**Before the Hearings Panel  
At Porirua City Council**

**In the matter of** the Proposed Porirua District Plan

**Statement of evidence of Graeme Robert McIndoe  
on behalf of Porirua City Council**

**Urban Design**

Figure 1 Site overlaid on 1m contours (from PCC GIS database)

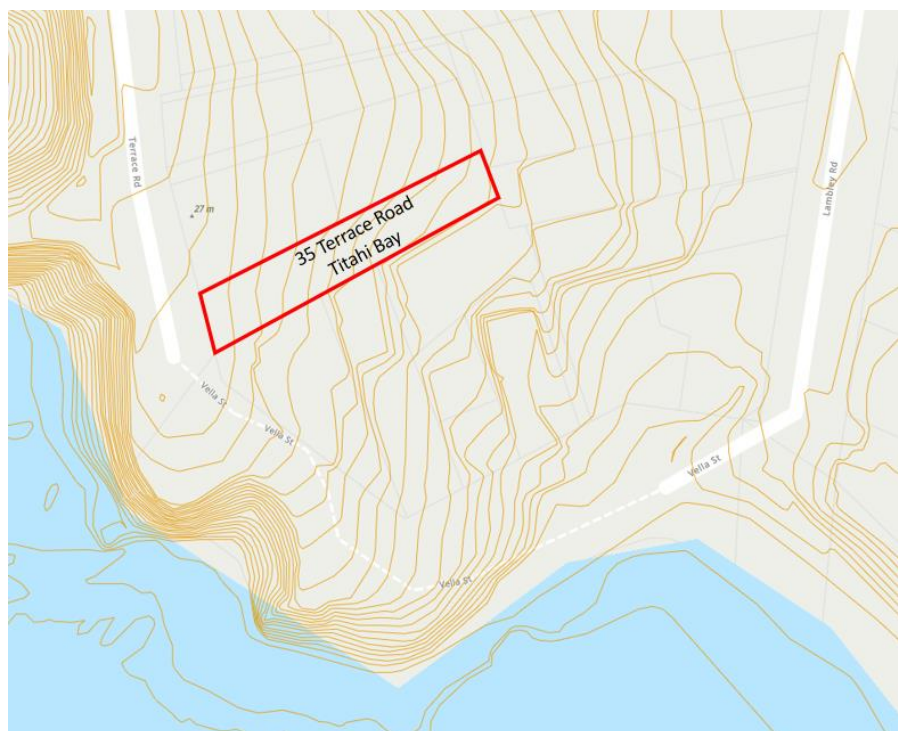
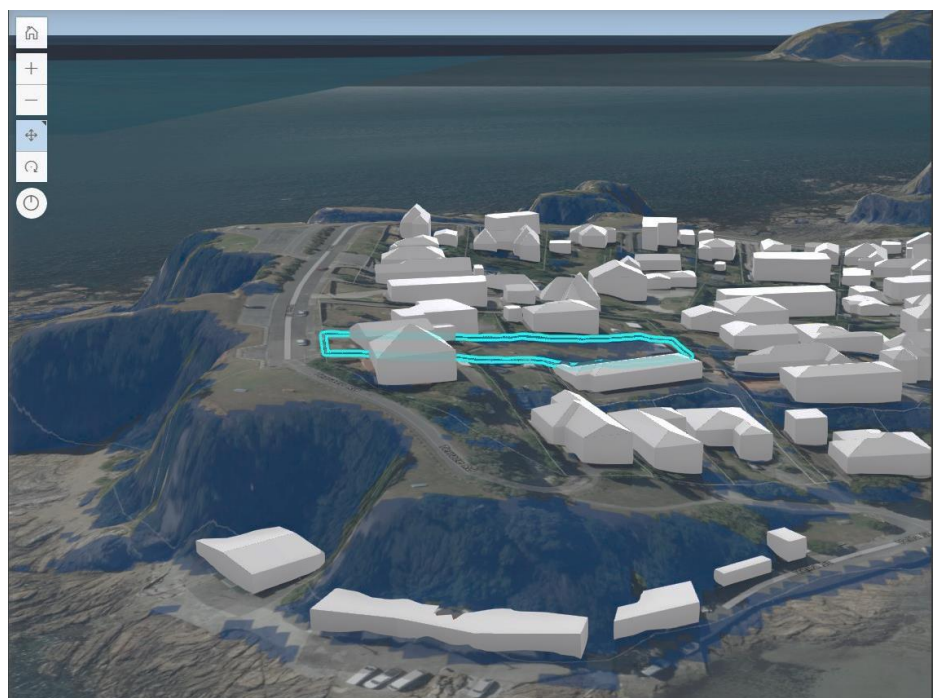
35.1 The submitters' site is included in the HVCA not because it is itself entirely a steeply south facing slope (as has been demonstrated by the Cuttriss Consultants Ltd survey drawing and PCC's own analysis) but primarily because it is at the top of a steeply south facing site. That notwithstanding, parts of 35 Terrace Road are steeply south-facing as defined in this methodology and these parts are illustrated below. Therefore, any tall and large building will in my opinion have downslope shading effects that should be mitigated by application of the HNCA to the site.

A combination of parts of edges of 35 Terrace Road being at 15 degrees south facing and the fact that it is at the top of an area characterised by south facing slopes means that it was identified as qualifying for the HVCA. To illustrate this, the 1m site contours relating to the site and sourced from PCC's database are described in Figure 1 below and the type of GIS-based drawings used to determine qualification as a HVCA are illustrated in figures 2 and 3.

34 **Recommendation**  
Reject the submission.

Figure 4 Testing shading effects of a two-storey house down the slope with north wall 26m from the boundary (A) and 10m from the boundary (B). [Figure 6 from Urban Design Memo #20]

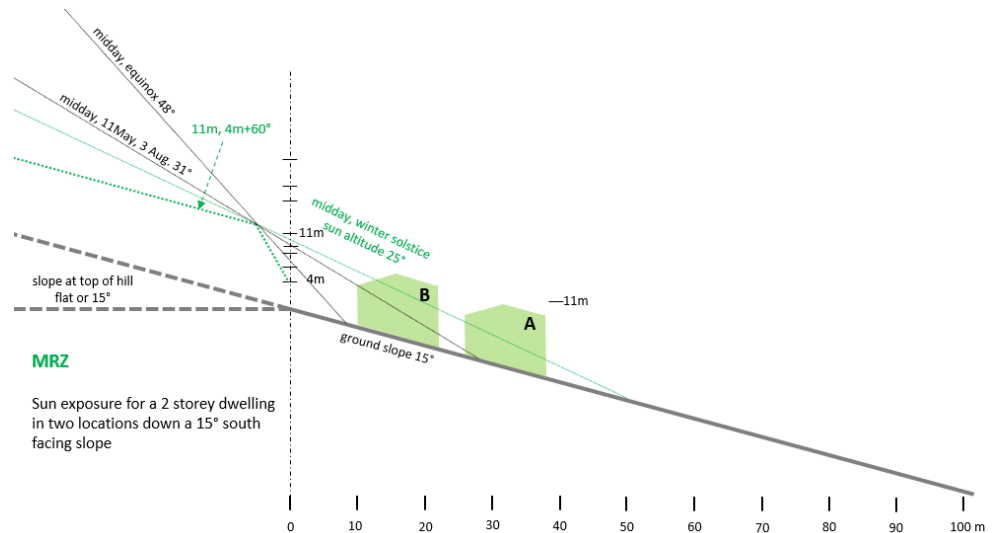
35.3 The impact of slope on shading effects is diagrammed in figure 4 below which has been extracted from Urban Design Memo #20. This and other similar diagrams all have a note identifying

“slope at top of hill flat or 15°” (with my emphasis added). This demonstrates that even if the site at the top of the slope were to be flat (and 35 Terrace Road is not), building on it will contribute to excessive down-slope shading.

Figure 5 Extract from MUL report: *Urban Design Advice on Rules and Standards (Part 3)* 11 August 2020, page 15).

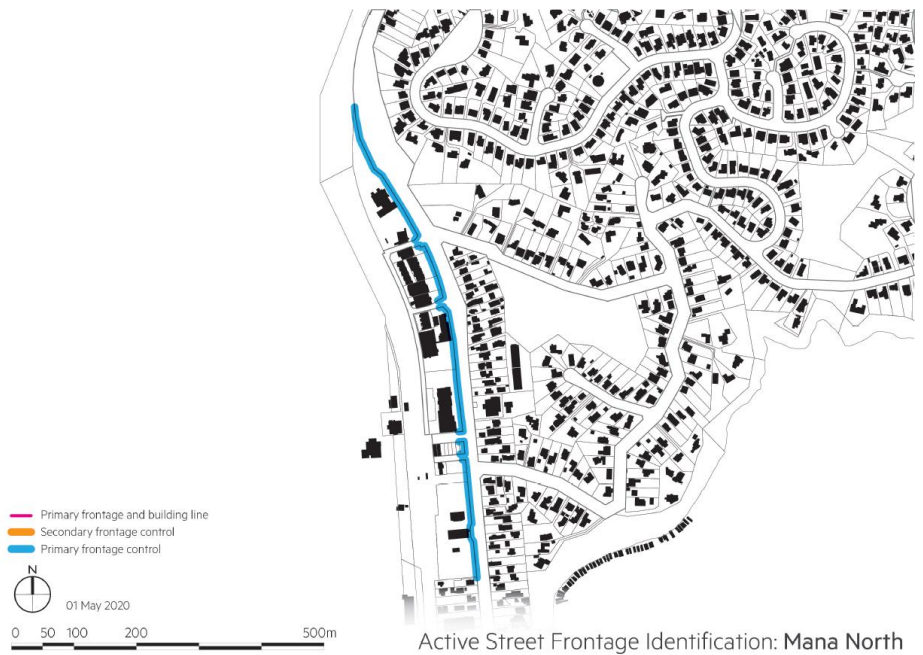
40.4 The application of the standard as currently expressed is also inconsistent with our analysis and advice for frontages at this site. We found that at Mana North *“discrete commercial developments have created a series of loosely aligned frontages along Mana Esplanade.... few buildings are accessed directly from the esplanade. Instead, they are approached via side roads, car parks and an elaborate on-site circulation system.... In this context, an ASF standard would impose an unnecessary constraint on future comprehensive redevelopment.”* Our recommendation following site visit and analysis is shown in Figure 5. The blue line in Figure 5 is *“Primary Frontage control”* rather than *“Primary frontage and building line”*.

Accept the Z Energy Limited submission in part and reject FS17.8. Reject that part of OS92.3 that calls for removal of primary frontage from 143 Mana Esplanade and change the definition of Primary Frontage in the plan as follows to respond to the issue raised by the submission:

- a. At least 55% of the ground floor building frontage must be display windows or transparent glazing; and*
- b. The principal public entrance to the building must be located ~~on~~ facing the front boundary.*

Figure 6 Extract from Variation 1 Proposed District Plan online planning map with my notes added. The grey green line is the extent of Primary Frontage

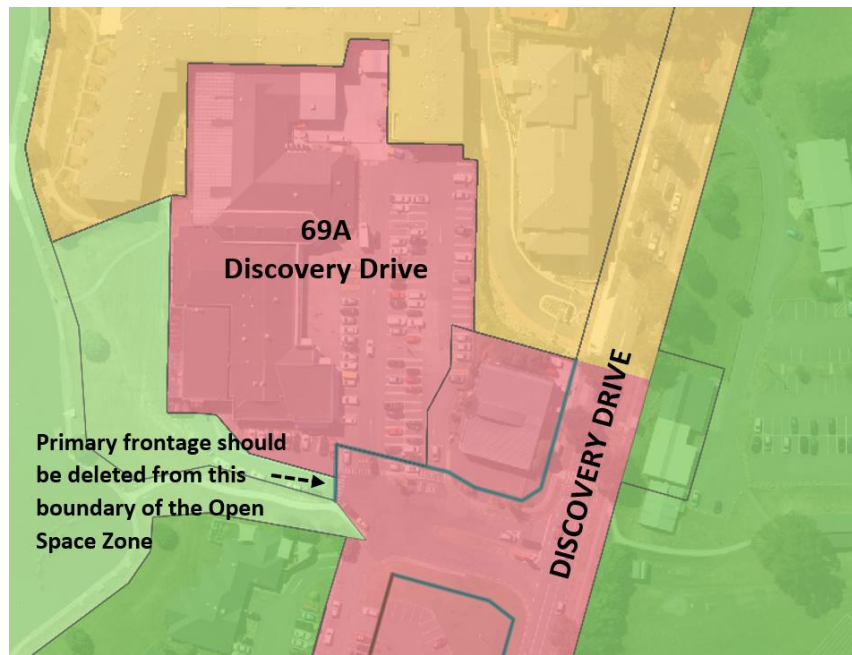
43.1 From our site analysis I do not consider a building line requirement appropriate here, nor that for a primary frontage which in my opinion remains relevant to this edge as shown in Figure 7, that the principal public entrance should be located on the site boundary as currently required by the ASF standard. Locating the entrance at the boundary

Subsequently as the work advanced, on 11 August 2020 we advised that the edge of part of the site be defined as a primary frontage as shown in Figure 7. This did not include a building line recommendation.

- a. Apply Primary frontage control only but with no building line control;
- b. Change the definition of Primary frontage in the plan (as described in recommended response to *Z Energy Limited Z MANA - 143 Mana Esplanade, Mana (s92.3)*); and
- c. Maintain Primary frontage control to the Section of 69A Discovery Drive that fronts/connects to the short stub of entry road in from Discovery Drive and that is on an east-west alignment as is shown below in the extract from the proposed plan (Figure 6) but with removal of Primary frontage control from across the access to the Open Space Zone.

Figure 8: 5 John Seddon Drive is identified with a yellow dashed line above, and the identified Secondary frontage control can be seen with the brown line in this screenshot from the PDP.

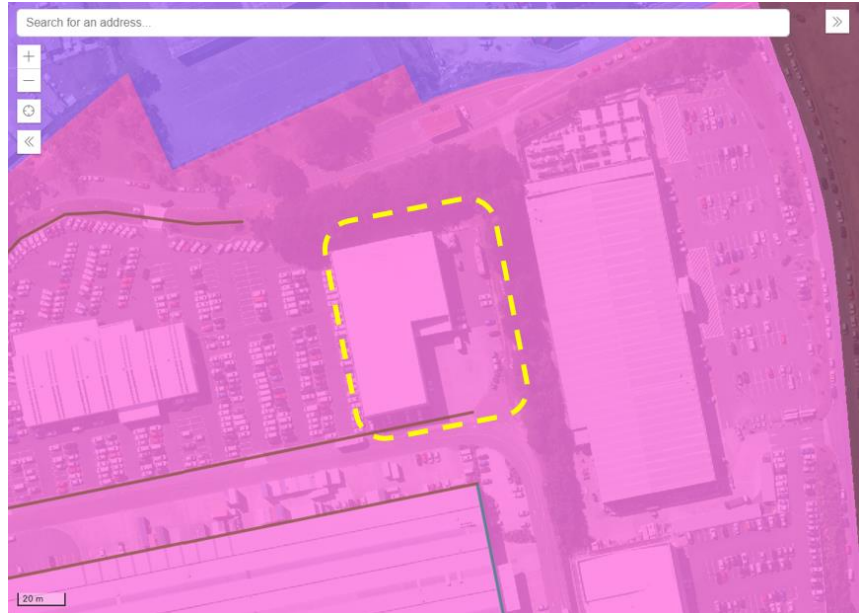
44 Harvey Norman Properties (N.Z.) Limited seeks removal of the Secondary Frontage Control from 5 John Seddon Drive. This is because the proposed Secondary Frontage Control has been applied to the southern boundary of the site, which adjoins a private driveway belonging to the neighbouring property. Harvey Norman Properties does not consider this control appropriate as this frontage is not a public road.

45 The 5 John Seddon Drive site (figure 8) and my city-centre wide analysis including the proposed LFRZ which informs this recommendation (figure 9) are shown below:
